JULY 1986

**COMMENTS ON
COST ESTIMATES IN THE
REGULATORY ANALYSIS
SUPPORTING THE
PROPOSED STATION BLACKOUT RULE**

**NUCLEAR UTILITY GROUP
ON STATION BLACKOUT
1200 Seventeenth Street, NW
Suite 700
Washington, D.C. 20036**

FIGURE 4-3

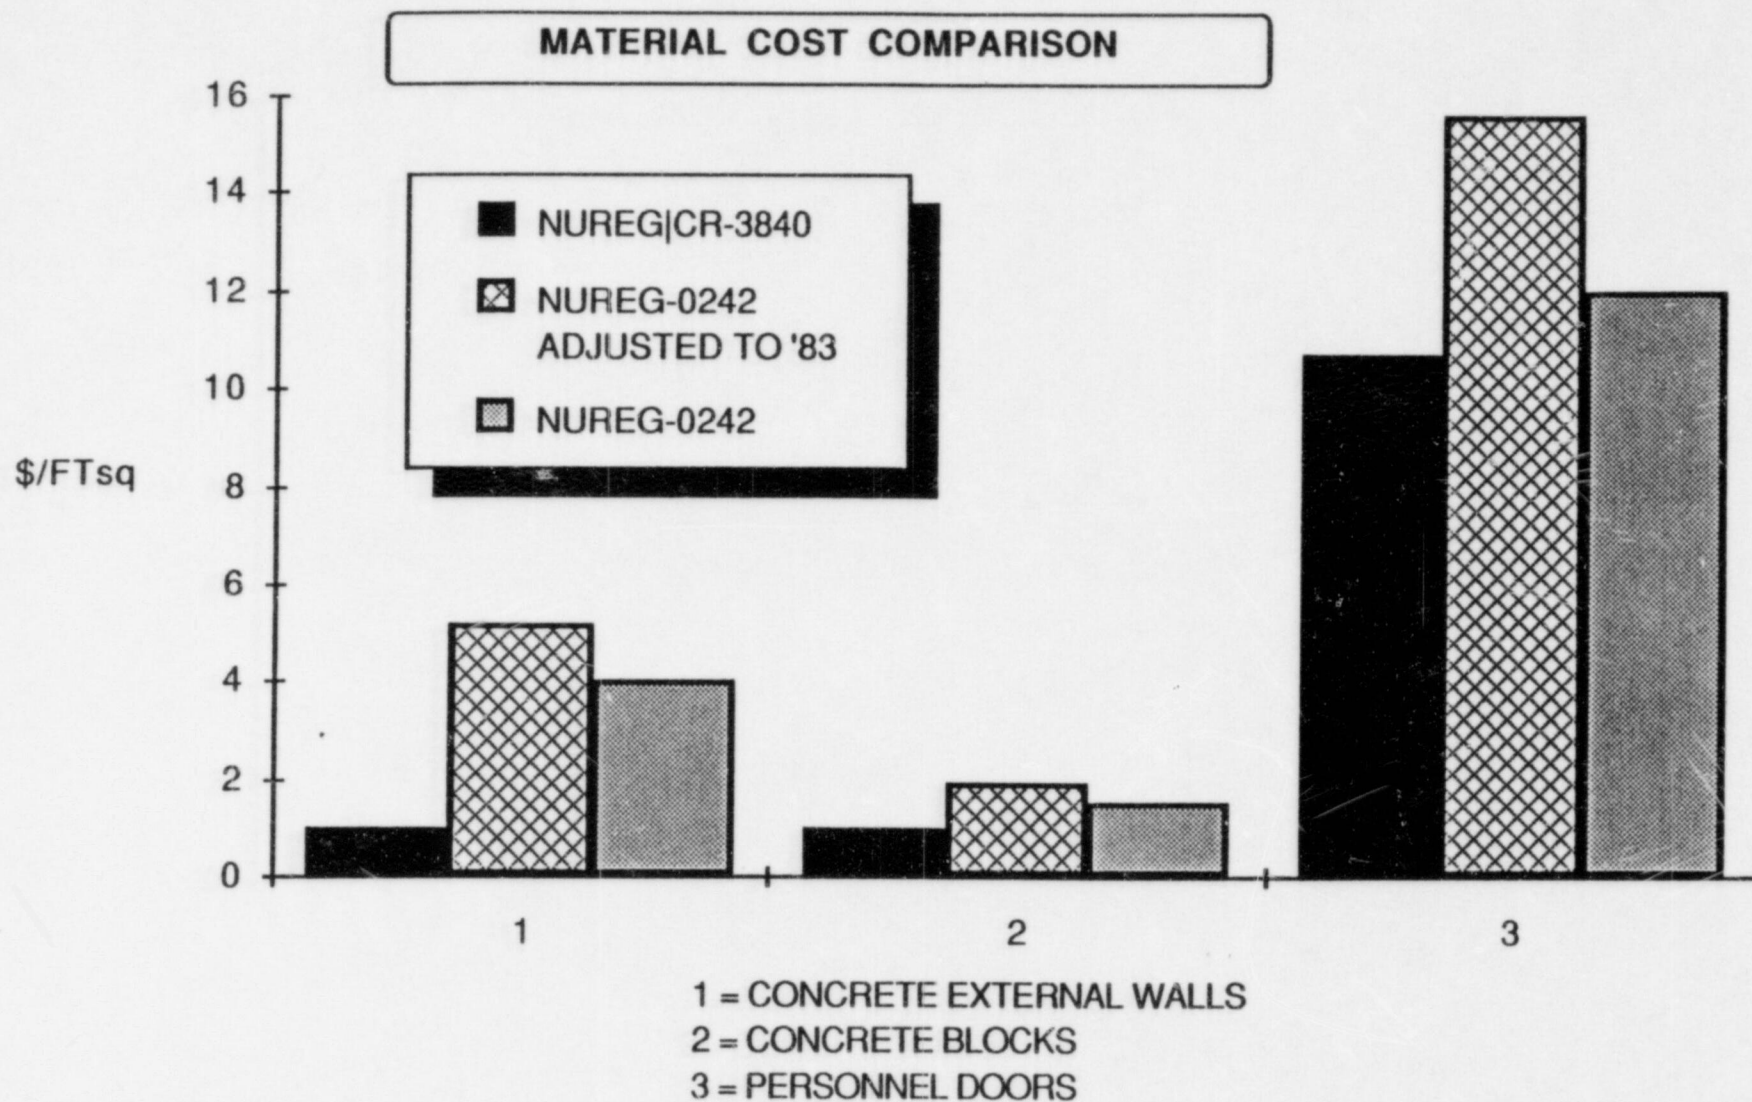
The inappropriateness of the Dodge Manual is also evident in comparing material costs (Figure 4-3). This figure illustrates recent material costs for the three items discussed. Costs are shown for the Dodge Manual, NUREG-0242 costs, and NUREG-0242 costs based on an average cost escalation of 30% since the 1977 NUREG-0242 study (see UEC [1984], page 3-3). The differences between these costs and those projected by the Dodge Manual are striking. In fact, some of the material costs estimated by NUREG/CR-3840 in 1984 for station blackout modifications are less than previously reported in 1977 for new PWR construction. Adjusting for the 30% average cost escalation experienced in commodity/equipment costs since 1977 only widens this gap.

FIGURE 4 - 4

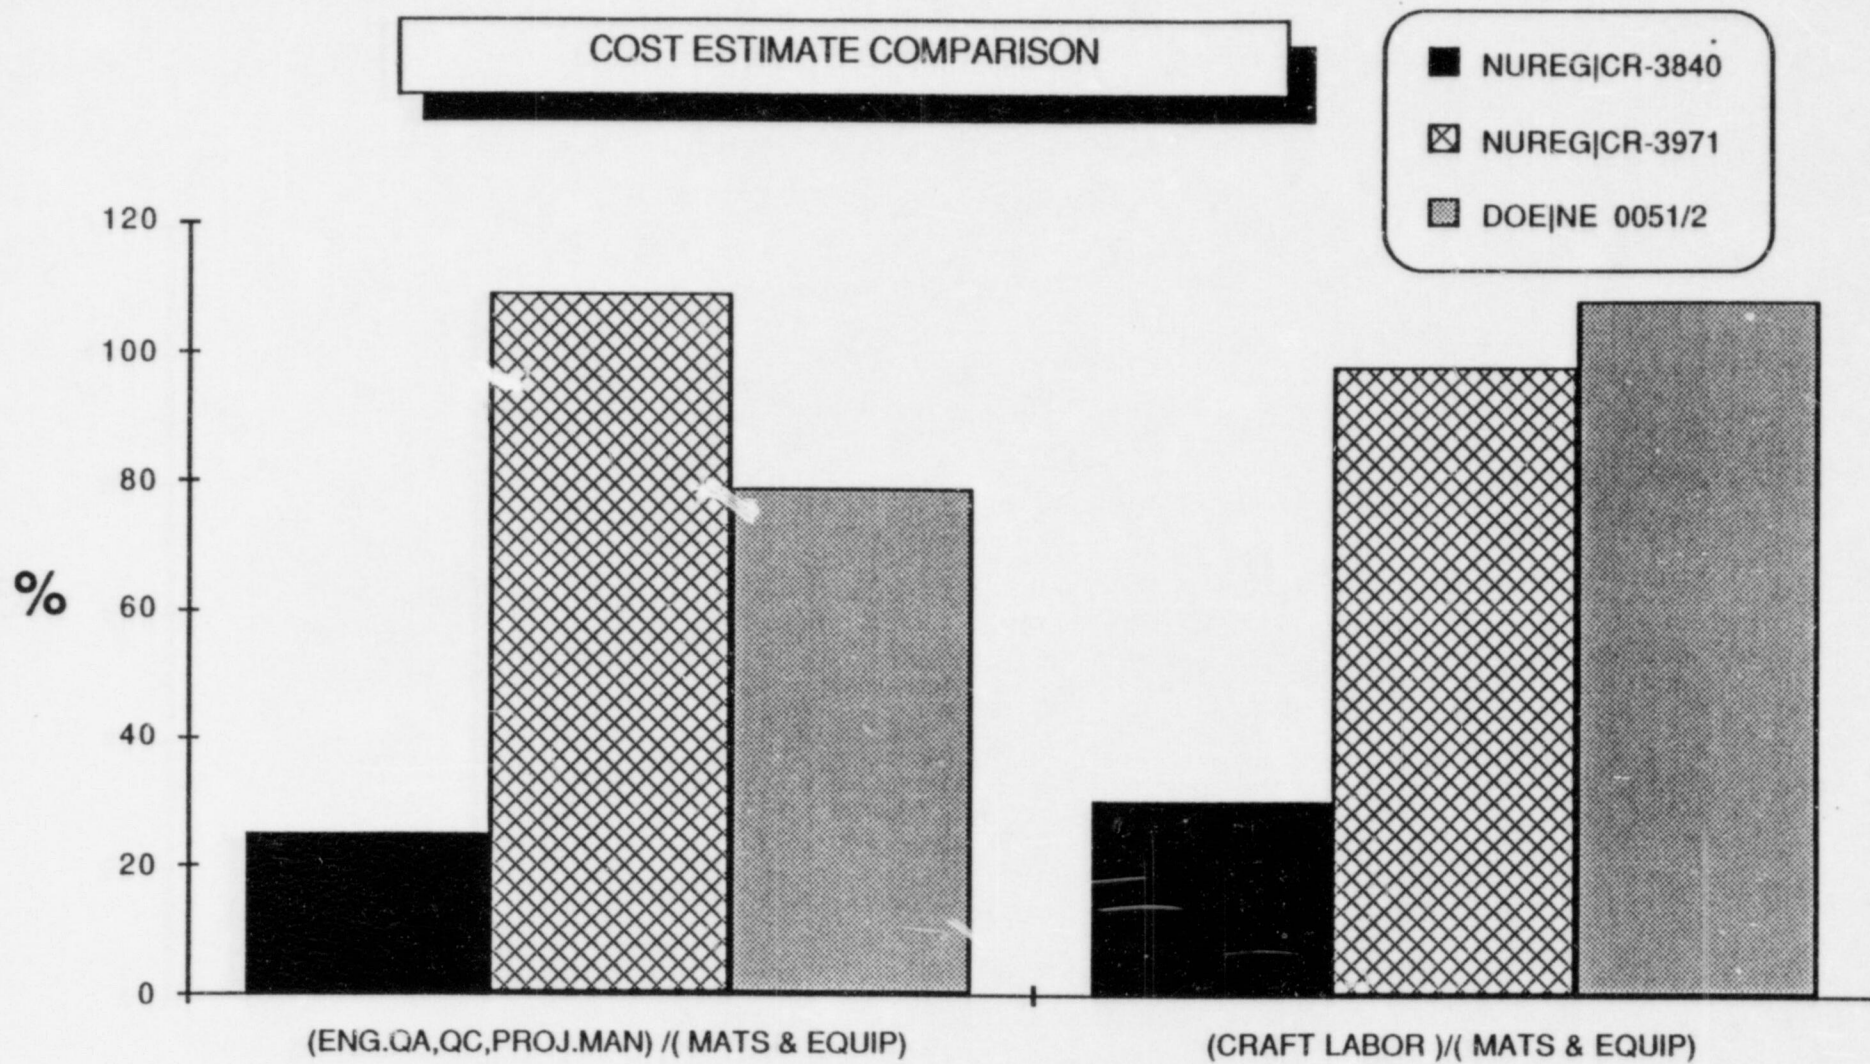
with the use of adjustment terms to account for overheads, as is done in the NUREG/CR-3840 analysis. This is best illustrated in Figure 4-4 which presents two overhead ratios for data presented in each of three reports: NUREG/CR-3840, NUREG/CR-3971, and the EEDB (DOE/NE 0051/2). The first ratio presents engineering, quality assurance, and project management costs to total equipment and material costs. The second is the ratio of craft labor costs to total equipment and material costs. These comparisons clearly demonstrate the systematic underestimates of these overheads by factors of 4-5 or more.

FIGURE 5 - 1

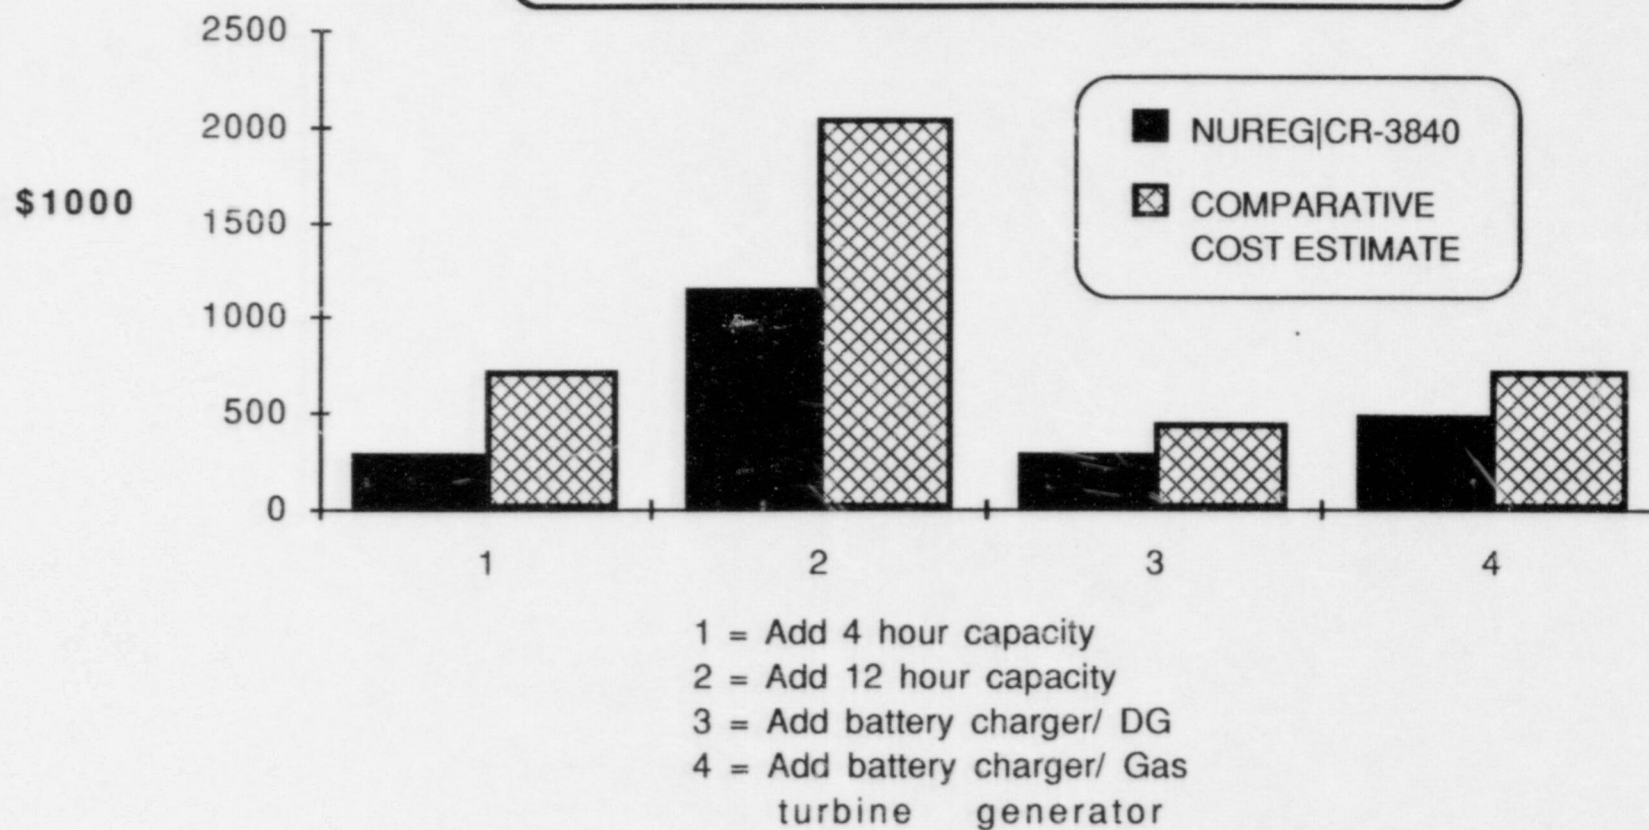
The results of the sensitivity analysis are provided in Figures 5-1 and 5-2 for the representative "base case" examples listed in NUREG/CR-3840. Figure 5-3 provides a category comparison for Option 2 in Figure 5-1. As is clearly evident, the modified analysis results are, for the most part, two or more times larger than the NUREG/CR-3840 base case estimates. These results are significant in themselves. Further, when replacement power is also added, the modified case estimate could exceed the base case by up to a factor of 500.
